training_status variable

In support of proposed response to comments #459 and #626

Leon Bruckman, Nvidia

Figure 178B-7—RTS update state diagram

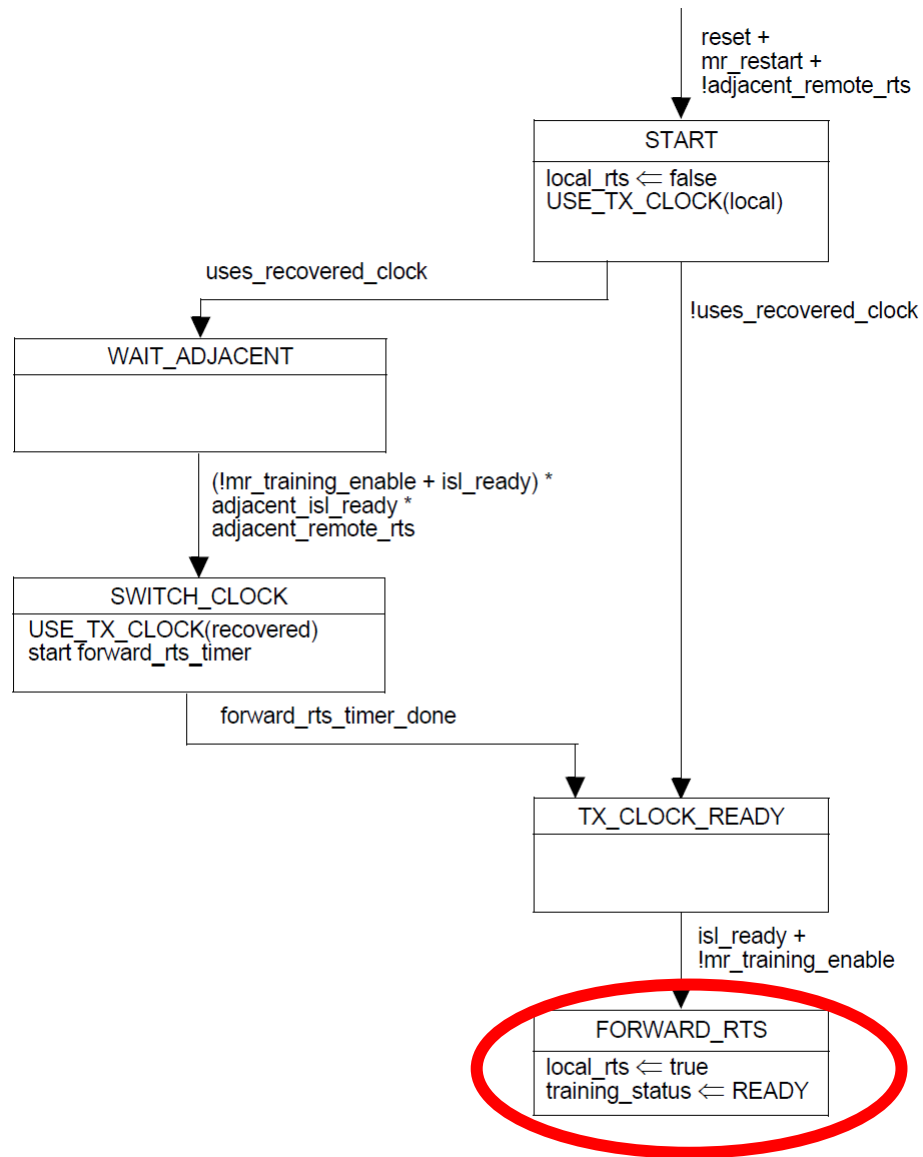
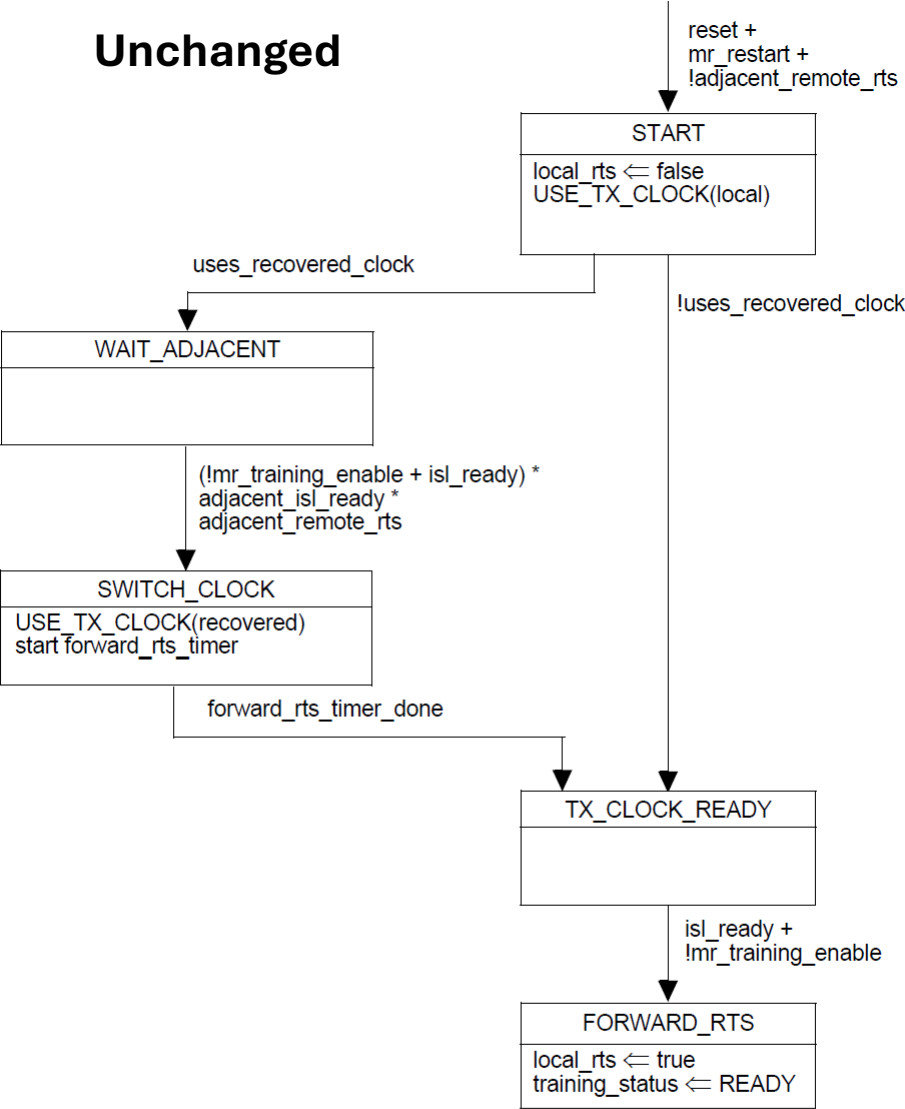
CI 178B	SC 178B.14.2.1	P 804	L 32	# 459
Slavick, Jeff				
Broadcom				
Comment Type	TR	Comment Status	X	
Training status can not be both a AUI component variable and a per-lane training variable. Local_rts is an equivalent status to it and is mapped to a MDIO register bit.				
SuggestedRemedy				
Move the definition of training_status to 178B14.3.1 Remove the enumeration of "READY" from its definition. Delete training_status <= READY from Figyre 178B-7				
Proposed Response	Response Status <input type="radio"/>

SuggestedRemedy				
Provide a definition for the training_status variable used in Figure 178B–8 'Training control state diagram' in its associated subclause 178B.14.3.1 'Variables'. In addition, clarify the operation of training_status regarding it being driven by both the per-interface 'RTS update state diagram' (Figure 178B–7) and the per-lane 'Training control state diagram'.				
Proposed Response		Response Status ○

- Change the definition of training_status in 178B.14.2.1 per-interface variables, to:
 - This variable may be assigned one of the following values: IN_PROGRESS, READY, OK, FAIL. The value READY is assigned by the RTS update state diagram (Figure 178B-8) and other values are assigned according to the lane_training_status variables (see 178B.14.3.1):

- IN_PROGRESS - if all the lane_training_status variables have the value IN_PROGRESS and local_rts has the value false
 - OK - if all the lane_training_status variables have the value OK.

- FAIL - if any of the lane_training_status variables has the value FAIL

Figure 178B-8—Training control state diagram

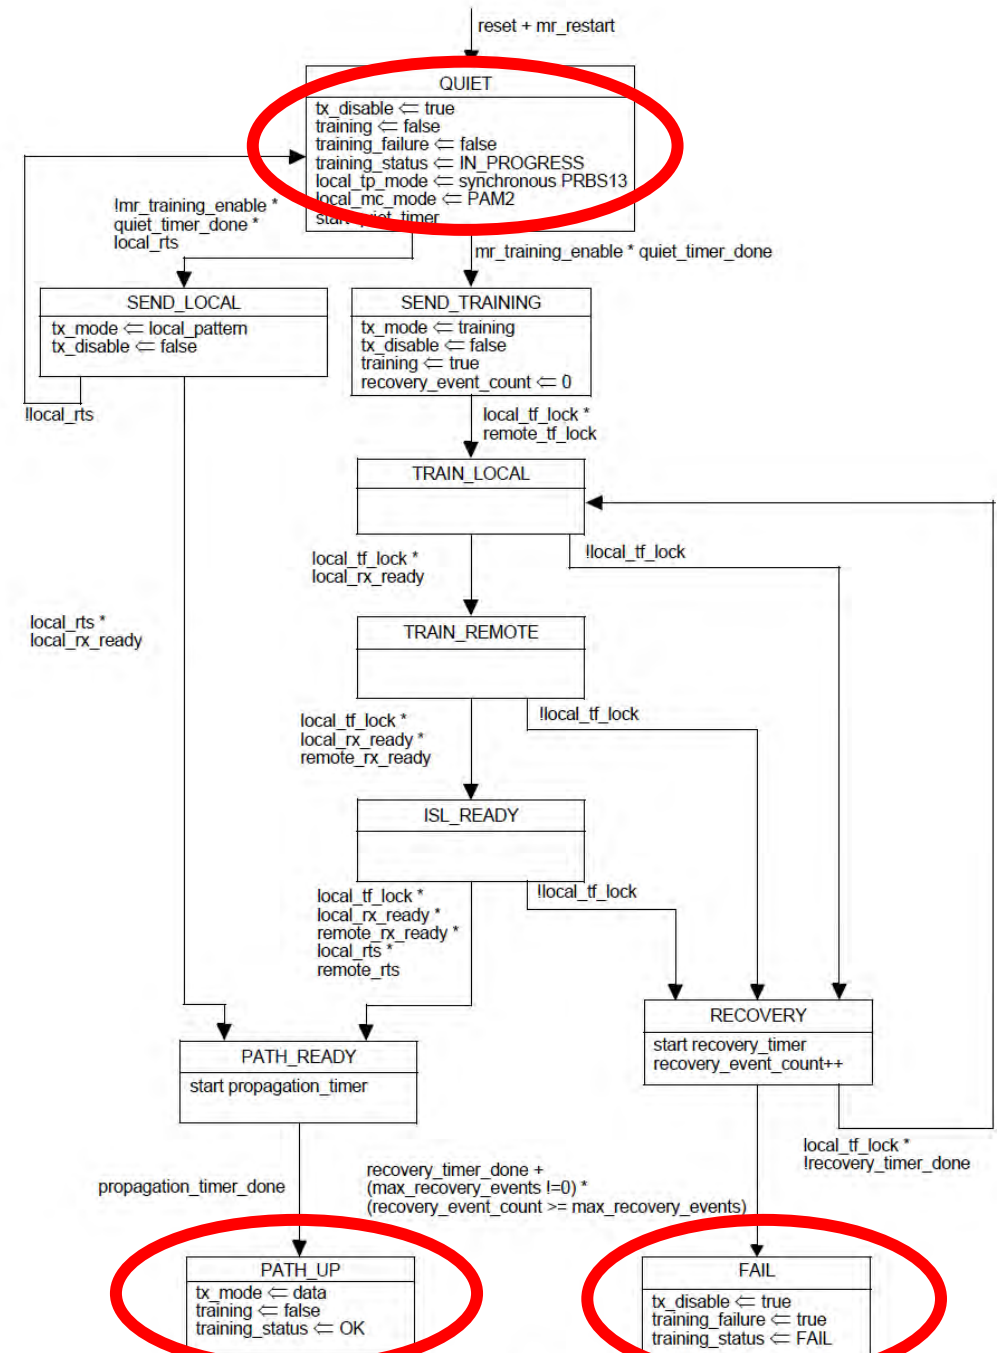
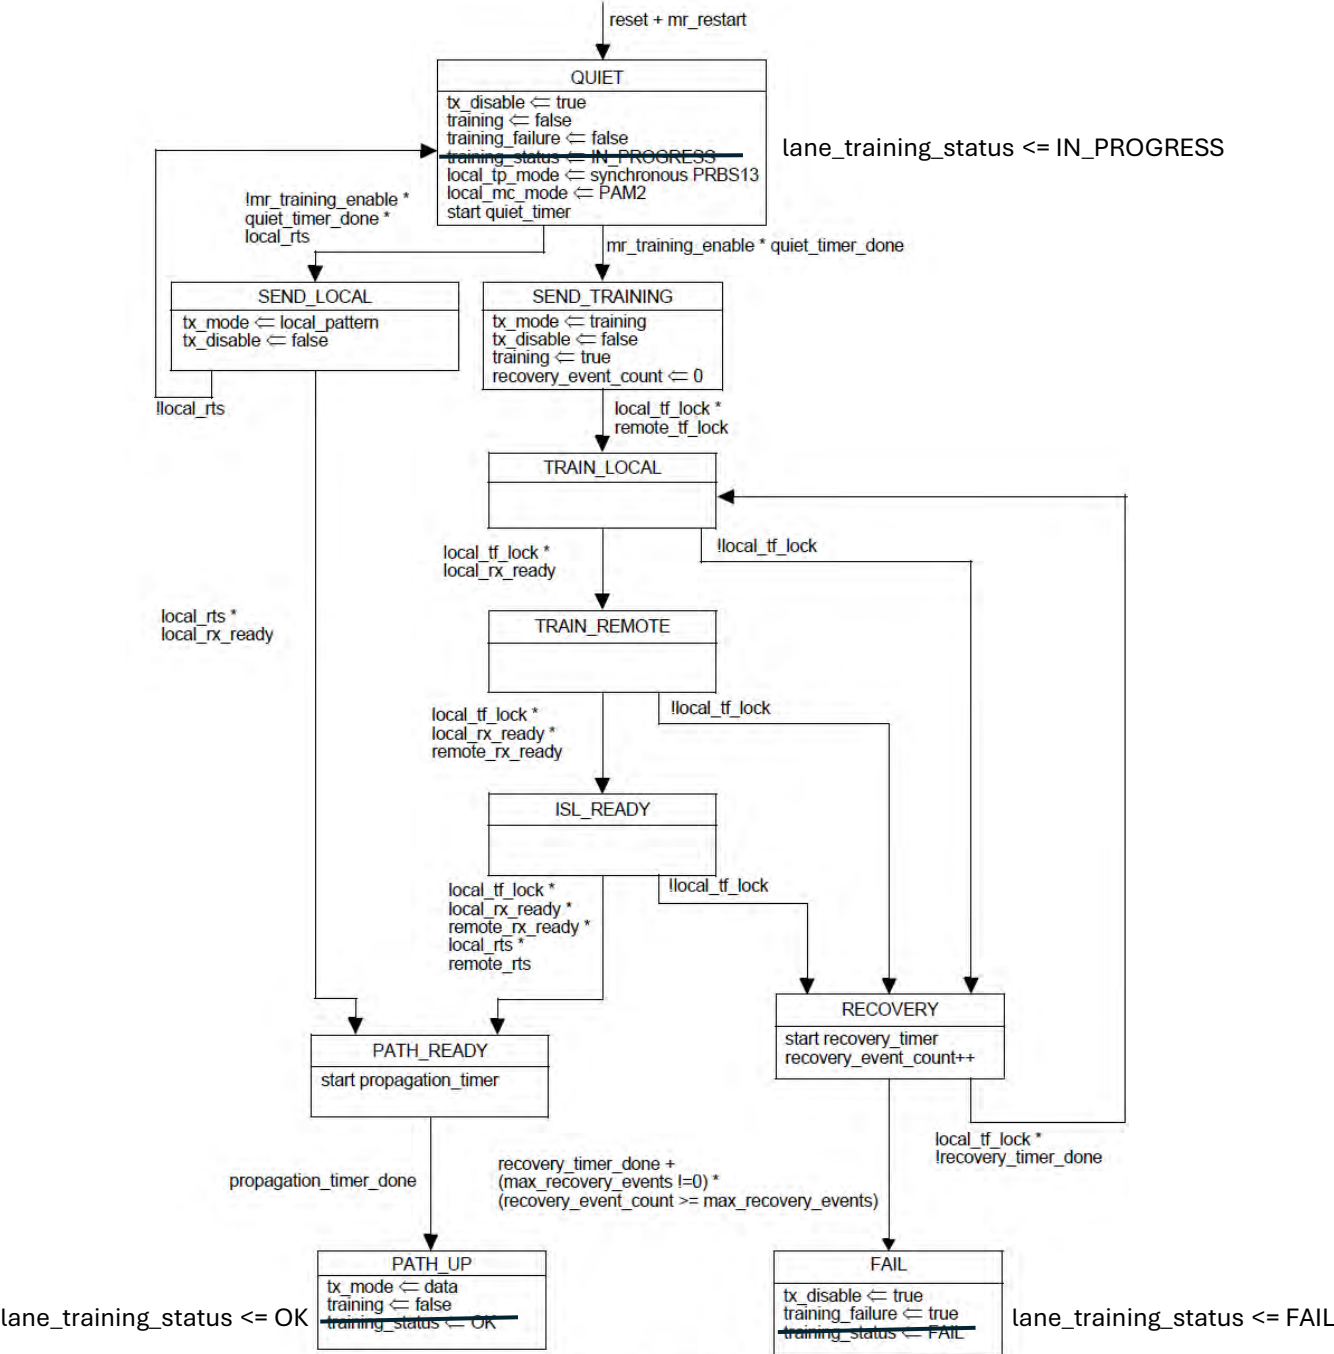
CI 178B	SC 178B.14.3.5	P 810	L 7	# 626
Law, David		HPE		
Comment Type	TR	Comment Status	X	
The variable training_status is used by the 'Training control state diagram' in subclause 178B.14.3.5 'State diagram figures' but is not defined in the associated subclause 178B.14.3.1 'Variables'.				
In addition, it appears that the training_status is a per-interface variable based on the definition found in 178B.14.2.1 'Variables', yet it appears to be driven by both the per-interface 'RTS update state diagram' (Figure 178B–7) and the per-lane 'Training control state diagram' (Figure 178B–8). I'm not sure how this would operate.				
As an example, if the Training control state diagram on one lane in an interface enters the FAIL state, it would set training_status for the interface to FAIL. If, however, the Training control state diagram on another lane in the same interface enters the PATH_UP state immediately afterwards, training_status for the interface would then be set to OK. This doesn't seem to be correct.

- Define a new variable in 178B.14.3.1 per-lane variables, to be used in the per-lane state diagrams instead of training_status.:
- lane_training_status

- Enumerated variable that indicates the status of the per-lane ILT function. This variable may be assigned one of the following values: IN_PROGRESS, OK, FAIL
